SERVICE BULLETIN SB99.7

UpRight PRD SUPT

Machines/Models: AB46 RT Diesel Serial Numbers: 1189-1657

PURPOSE: Add timer to fuel shut off circuit.

Figure 1

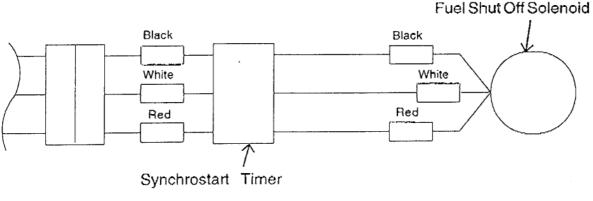
- 1. Using the supplied splices connect the timer in line to fuel shut off solenoid per the following schematic. See Figure 1 & 2.
- 2. Perform Pre-Operation and Safety Inspection as instructed in the Operator Manual.
